**Re: Pre-Application Assessment Form**  
**Pre-Application number: PE2022-01080**

**Application Number:** PE2022-01080  
**Site Address:** 3416 3 AV NW  
**Community:** PARKDALE  
**Applicant:** Sholdice, Trevor

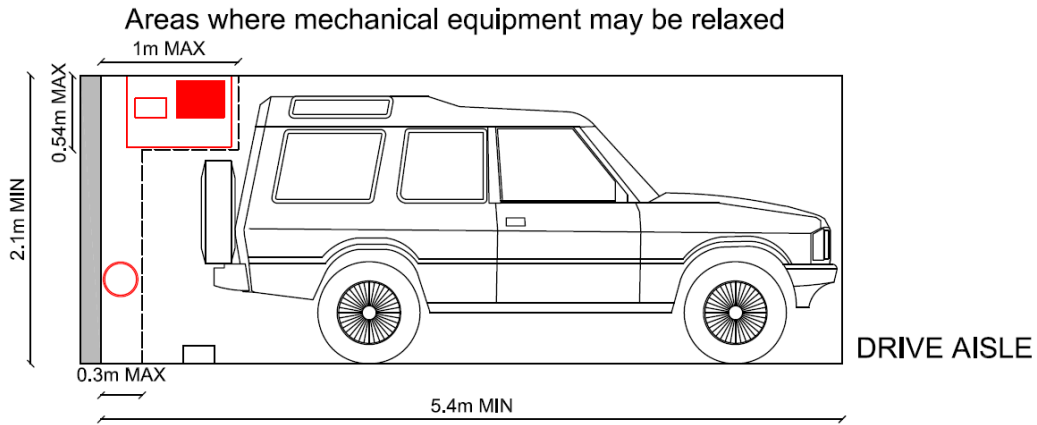
26. Amend the drawings to provide a detailed cross-section of the proposed external and internal parkade ramps, indicating all grades, transitions and elevations to current City standards. For details, please refer to Manual Standard Specifications for Road Construction, Figure 78, File# 454.1010.003.

- a) The minimum grade section length between transitions is 4.5m.
  - b) The minimum overhead clearance for a parkade is 2.1m and the plans shall indicate the same.

- c) The maximum grade change between transitions is 12 percent.
- d) The grades shall be measured on the inside of the curve on spiral ramps. (The shortest and steepest sections of the curved ramps.)

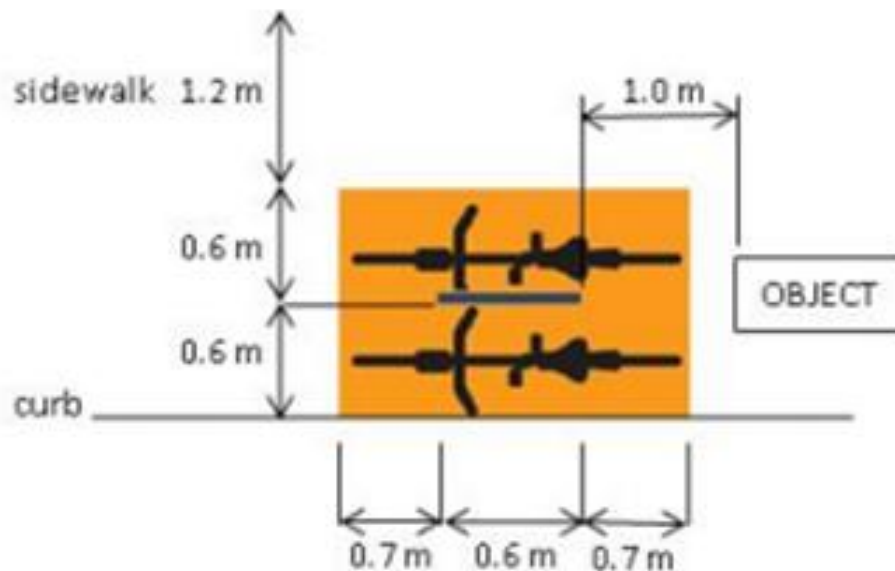
- 27. Amend the plans clearly dimension the proposed volumetric encroachments within the parkade. The volumetric encroachments shall not exceed the maximums as outlined in the detail below.
